Addendum No. 1
May 28, 2020

Project: Wegner Library Renovation
University of South Dakota
Sanford School of Medicine
Sioux Falls, South Dakota
OSE Project #R0620--21X
Architecture Incorporated Project #2875

Architect: Architecture Incorporated

**WEGNER LIBRARY RENOVATION -
OSE# R0620--21X
FIRST & SECOND FLOOR PLAN - VENT. & A/C**

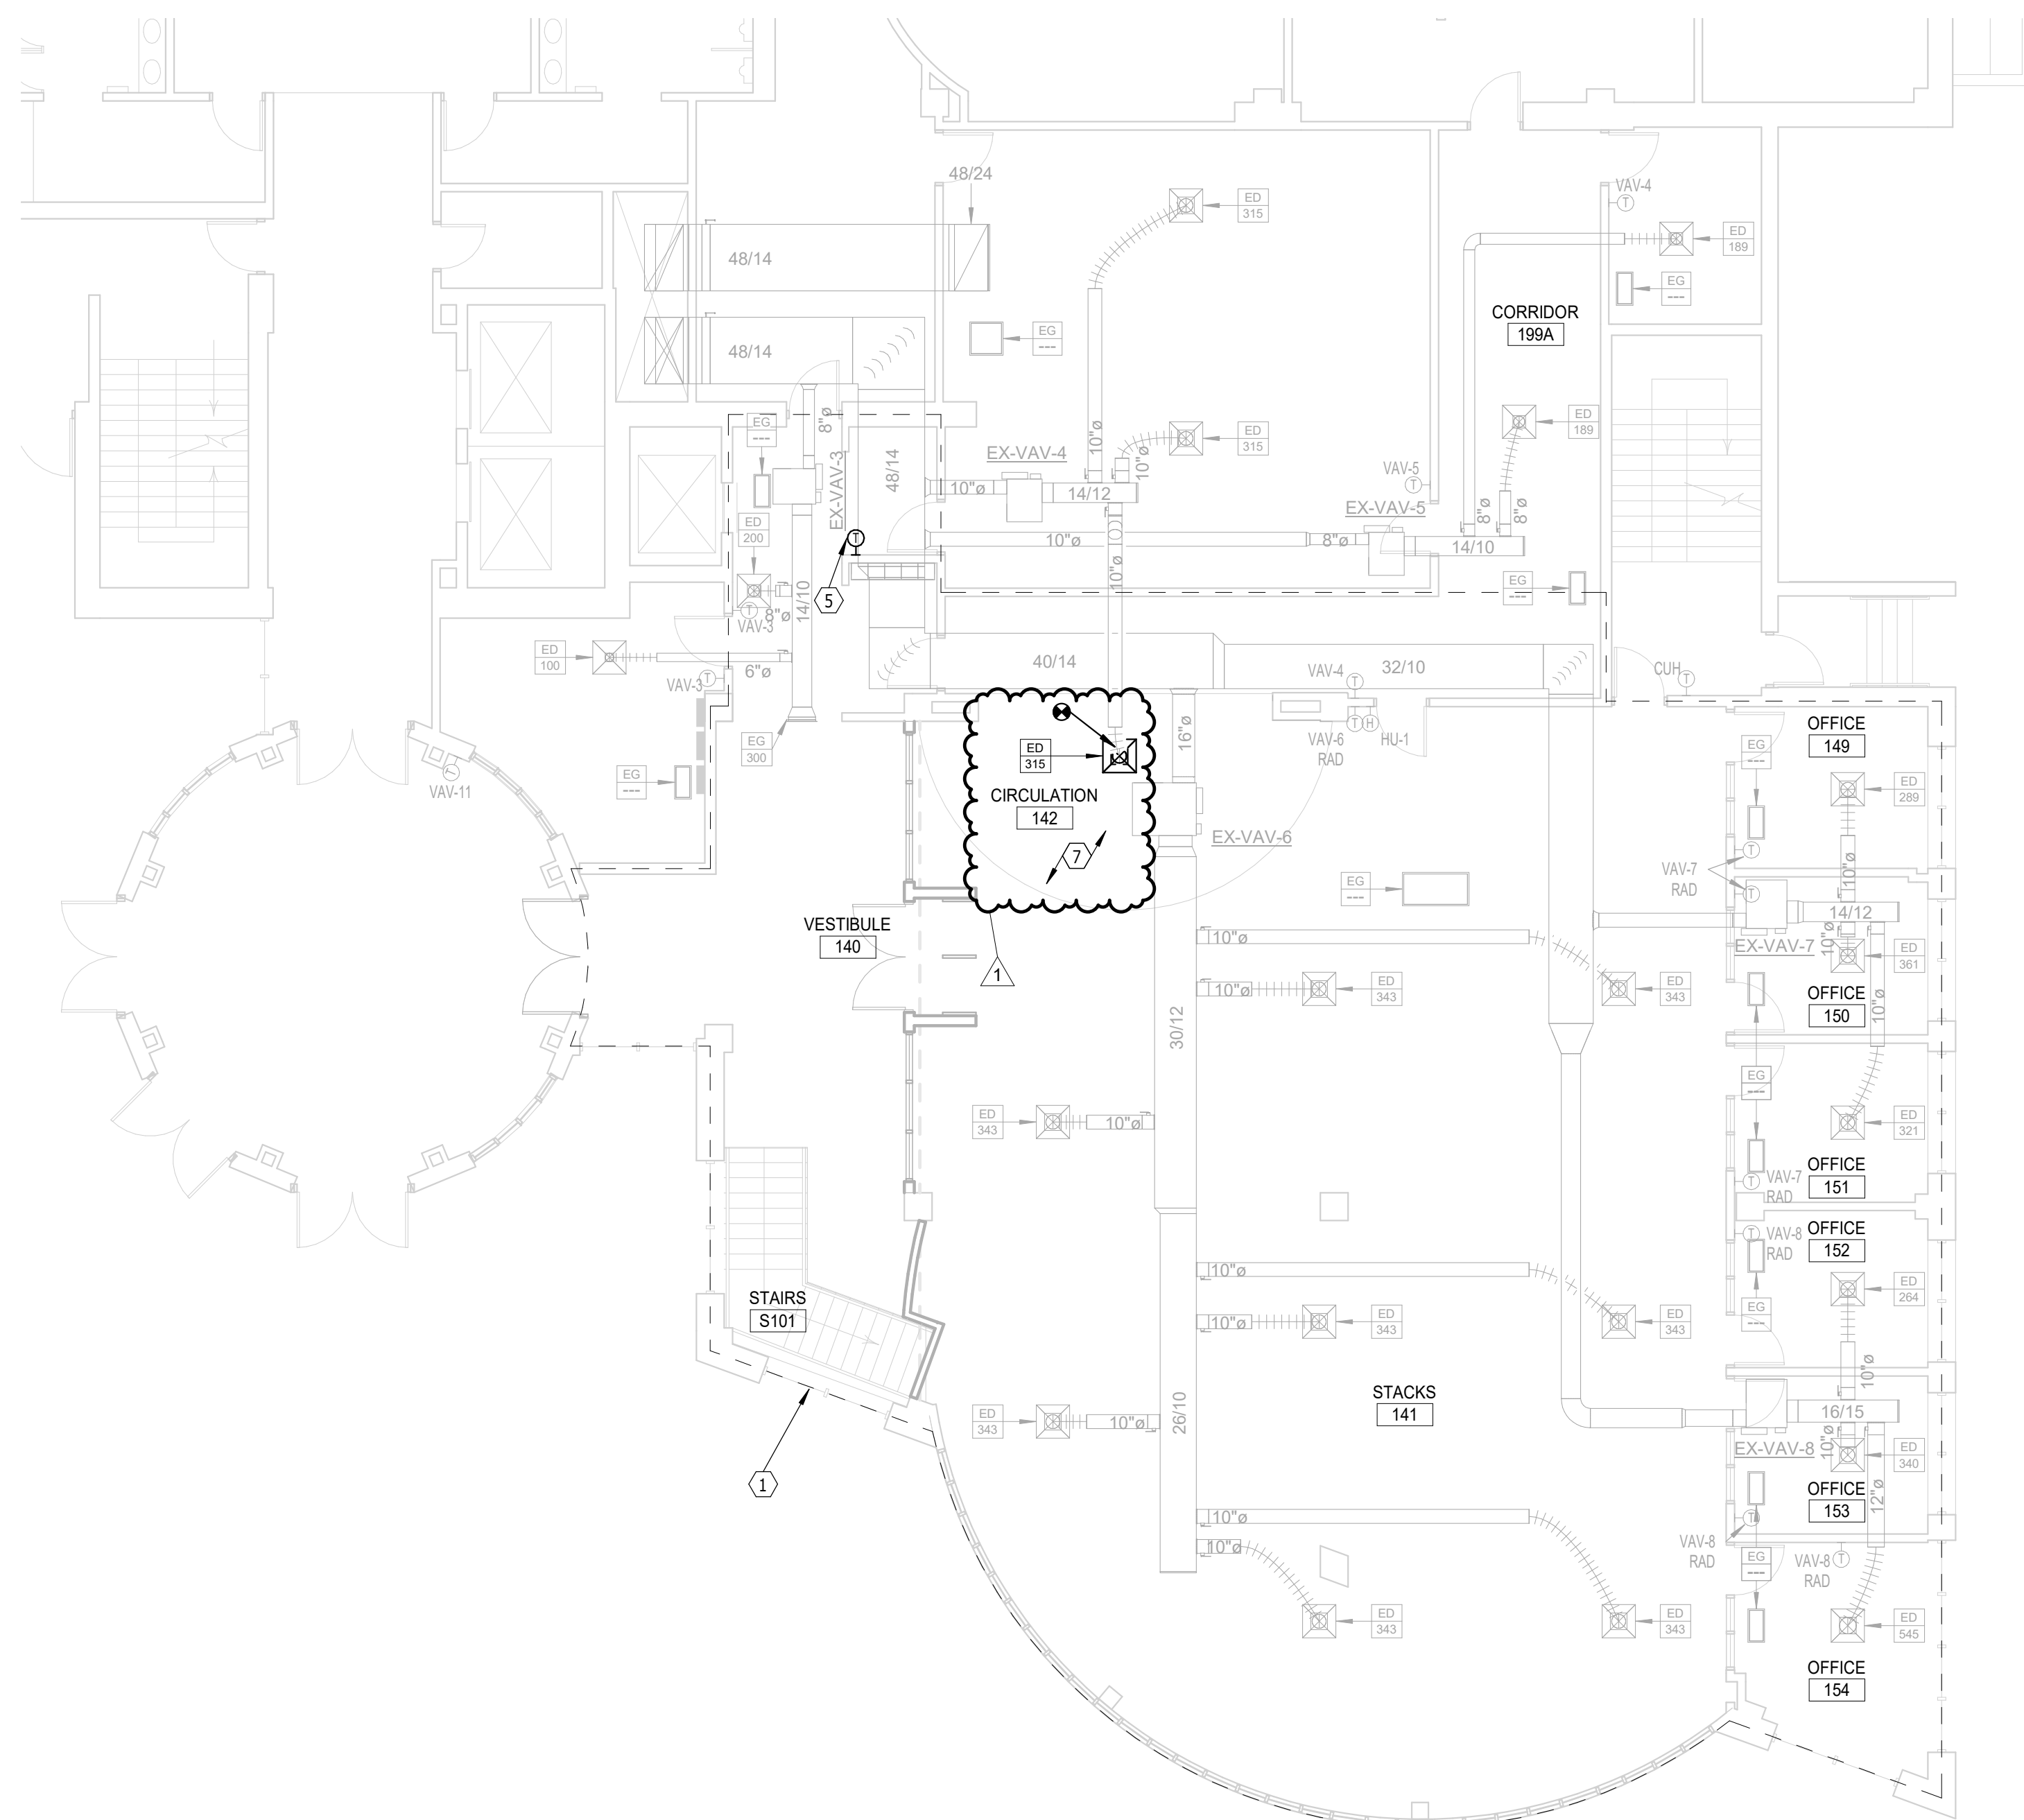
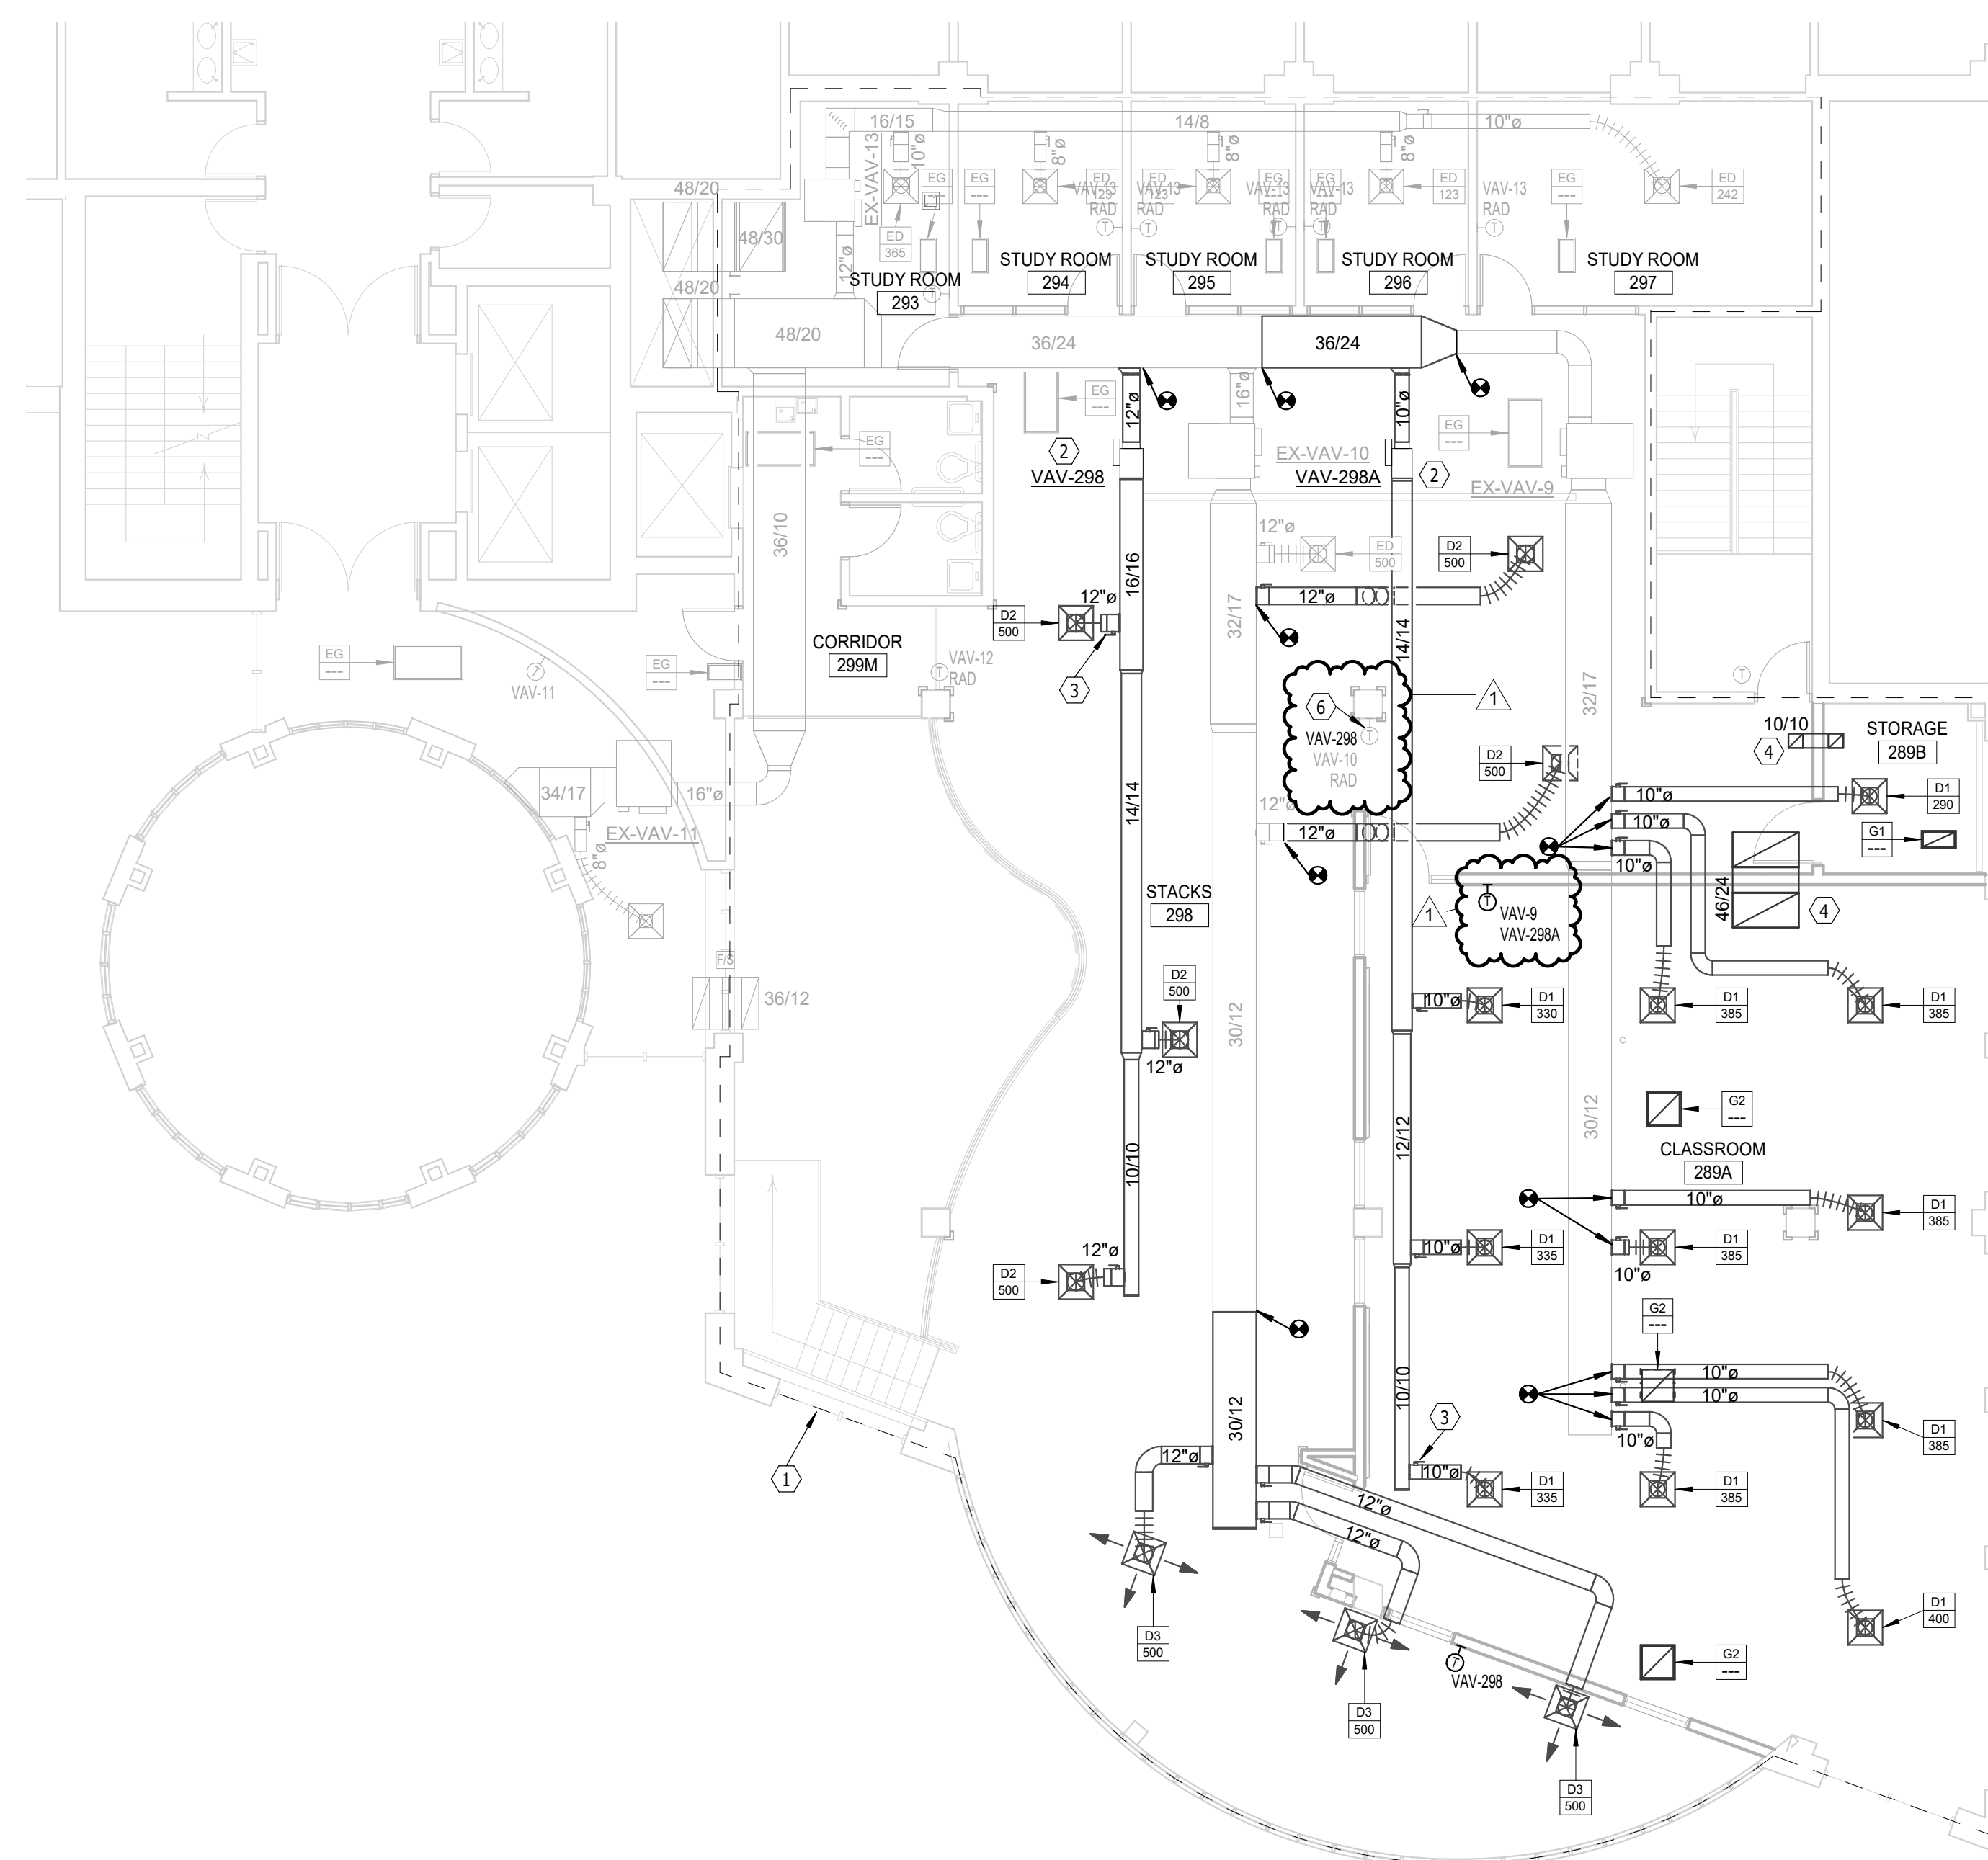
- a) Connect existing VAV-9 to new thermostat in new Classroom. Refer to attached revised drawing sheet 8.31, dated 05-28-20.
- b) Connect new VAV-298 to existing thermostat. Refer to attached revised drawing sheet 8.31, dated 05-28-20.
- c) Re-install existing grilles/diffusers that were removed during demolition on First Floor. Refer to attached revised drawing sheet 8.31, dated 05-28-20.

1. MODIFY EXISTING FIRE SPRINKLER SYSTEM AS REQUIRED PER NFPA 13
2. COOLING ONLY VAV.
3. BALANCE DAMPER, (TYP)
4. TRANSFER AIR DUCT MOUNTED ABOVE CEILING.
5. RELOCATED EXISTING THERMOSTAT
6. CONNECT NEW VAV-298 TO EXISTING THERMOSTAT.
7. RE-INSTALL ANY DIFFUSERS/GRILLES REMOVED DURING DEMOLITION.
